TOWN OF EASTON
PLANNING & ZONING
14 S Harrison Street, Easton MD 21601

Historic District Commission Staff Report

Meeting Date: 11/14/2022

Property Address: 209 Port Street

1 SOUTH ELEVATION

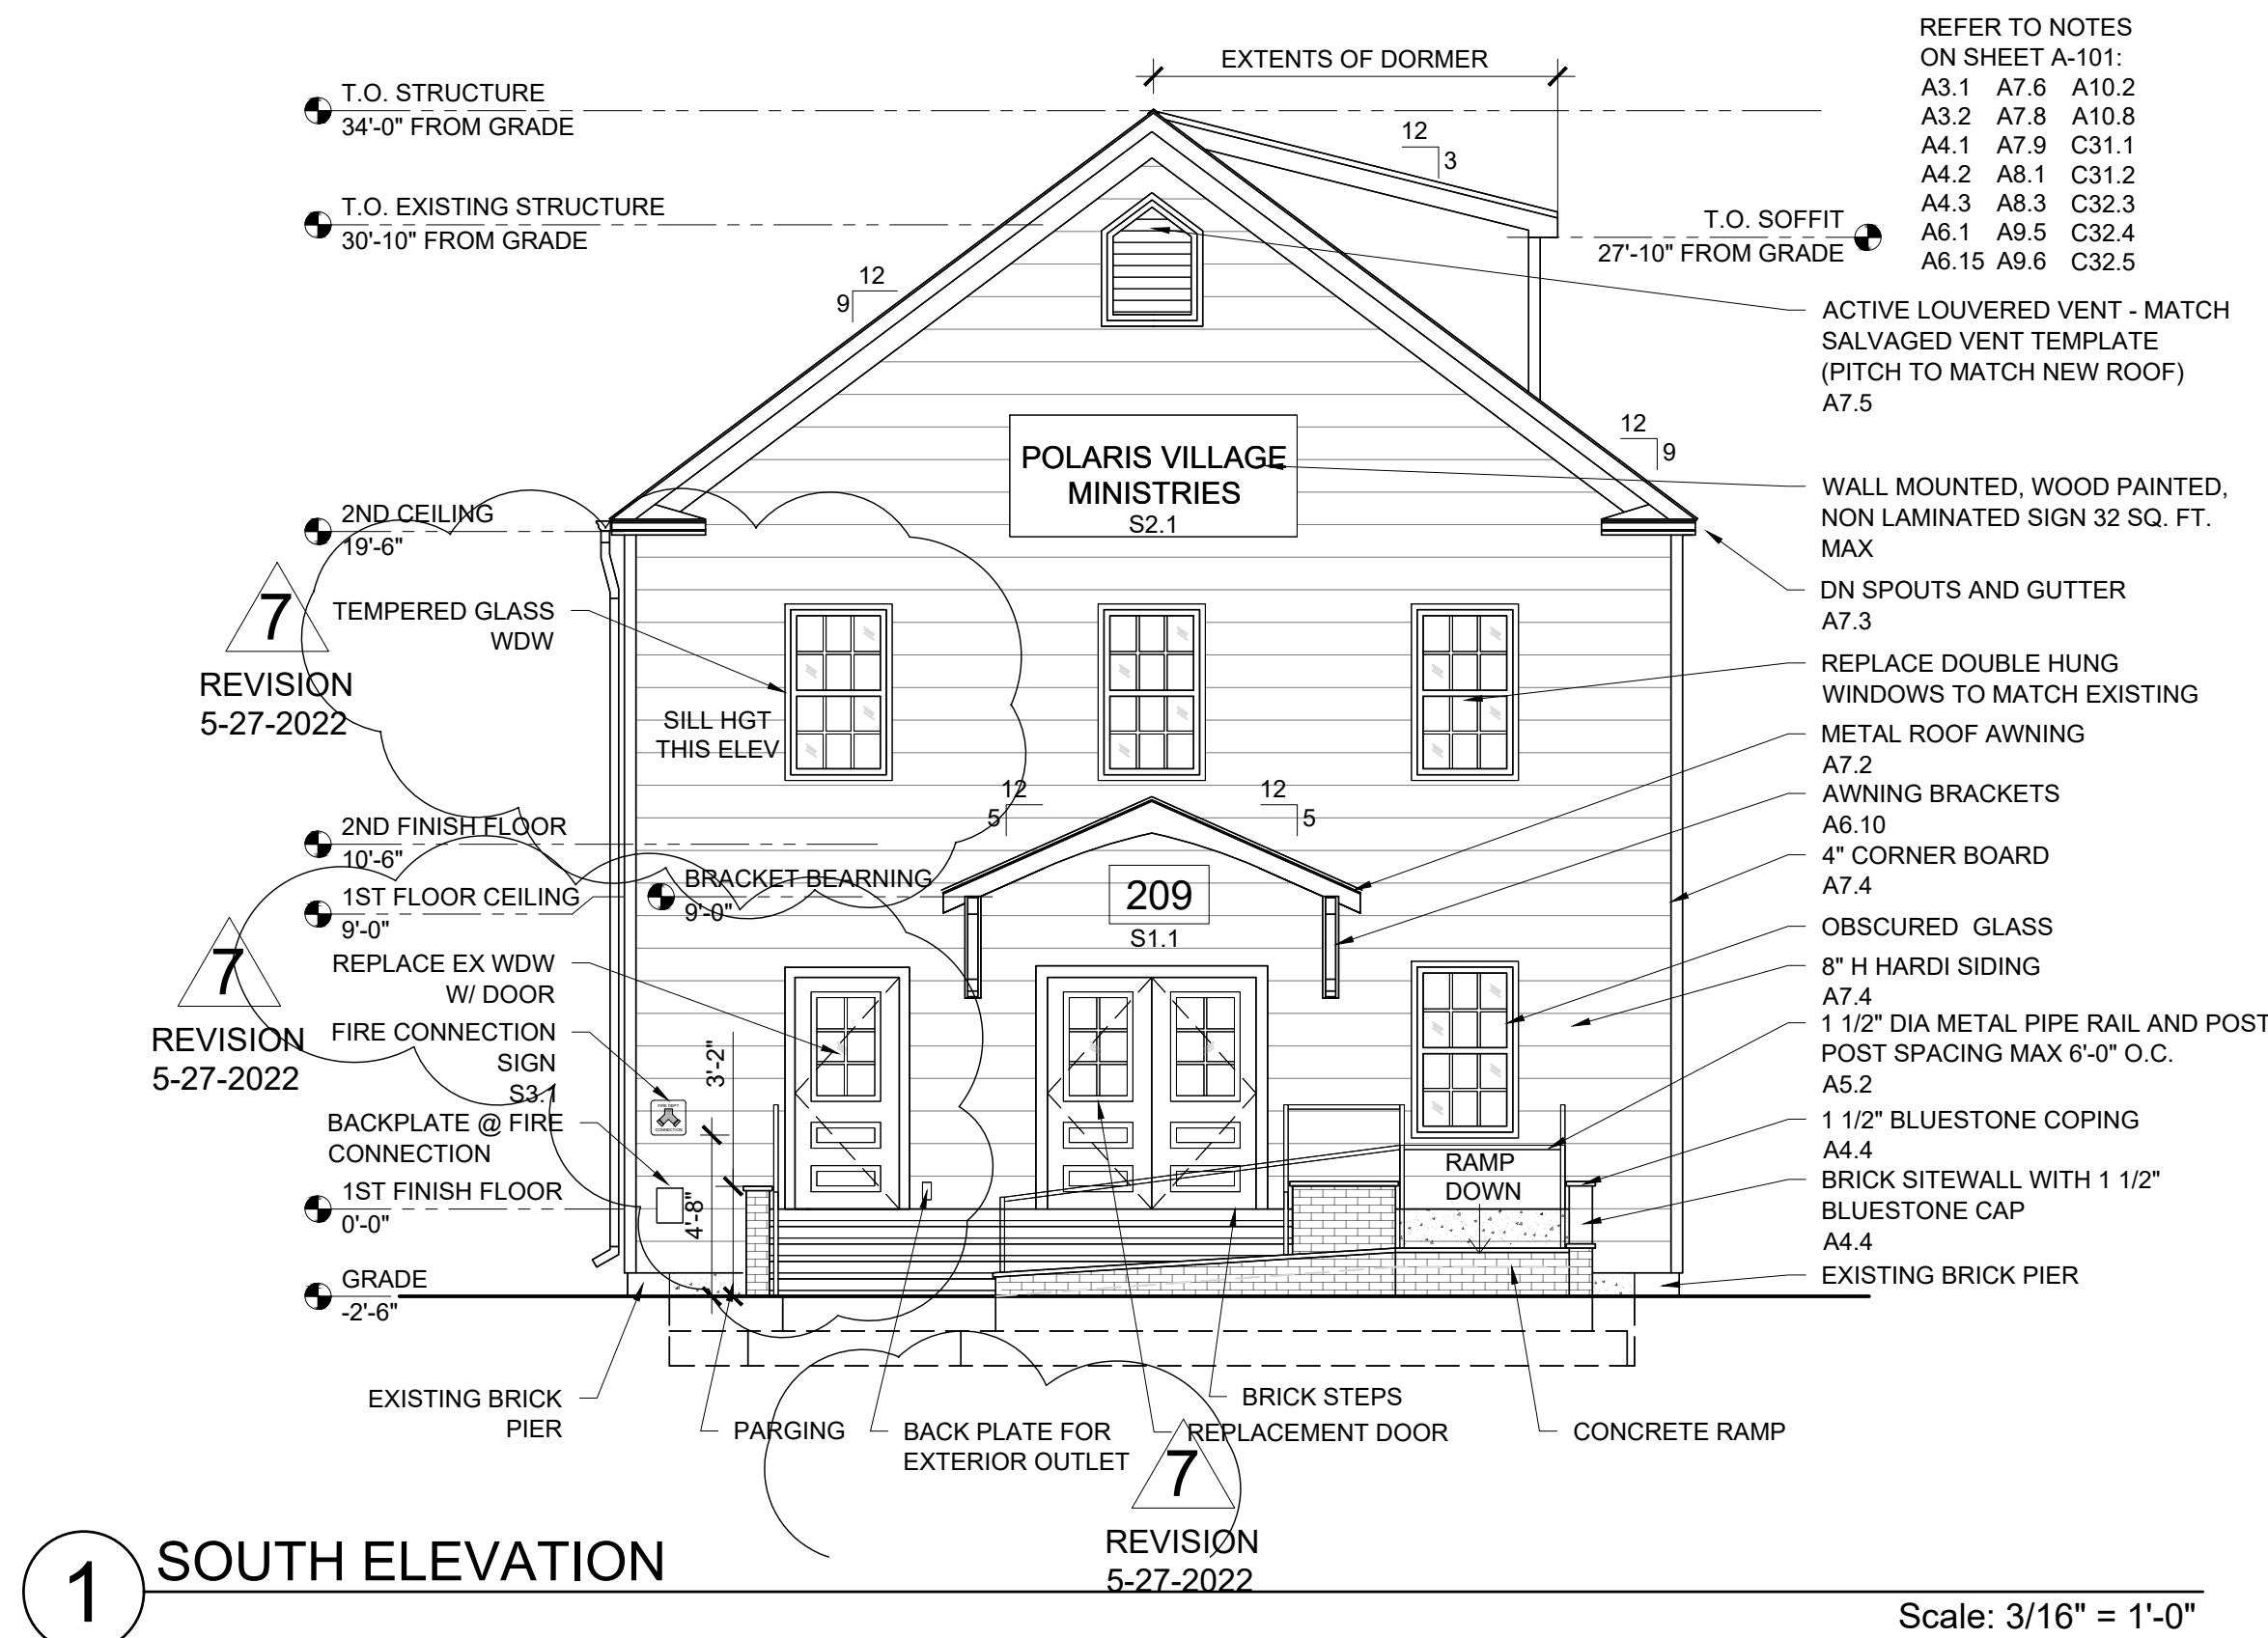
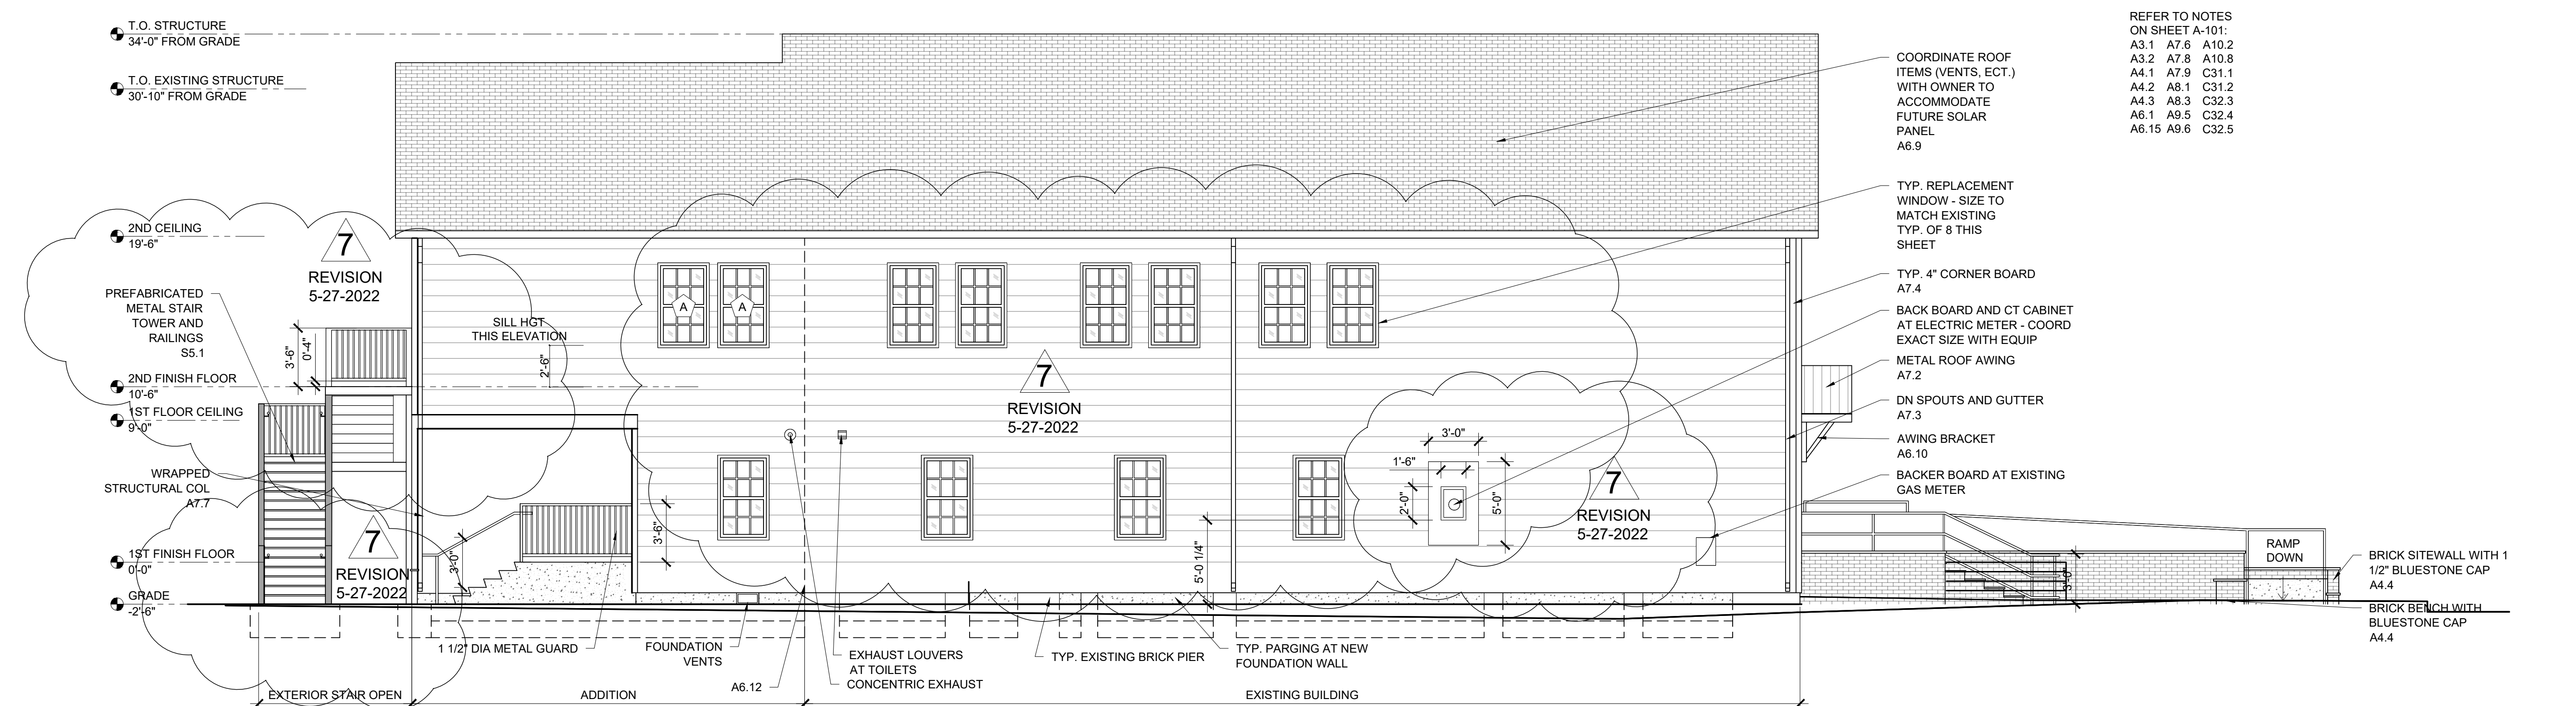
- SHEET A-201: The first floor window on the left side of the front (Port St.) elevation has been changed to an exit door. This is to satisfy a requirement from the Fire Marshal for the interior egress stair to have a dedicated exit discharge. The new exterior door design will match the previously approved main entrance doors, with a single leaf vs. double door configuration.
- SHEET A-201: The West facing exterior wall includes reconfigured window locations and quantities, also related to the changes to the interior dictating by the Fire Marshal's requirements. The windows are all the same size and style as those previously approved.
- SHEET A-202: The roof over the rear exterior egress stair from the second story has been deleted from the project.

Here's a snapshot of the exterior door we had to add to the front elevation to meet the Fire Marshal's requirements for a dedicated exit from the stairwell.

- One of the front windows will be changed to become a door to accommodate egress from the second floor.
- Changes were made to the front stairs.
- Removed overhang from the back stairway in the rear.
- Change the window configuration of the west-facing exterior wall.
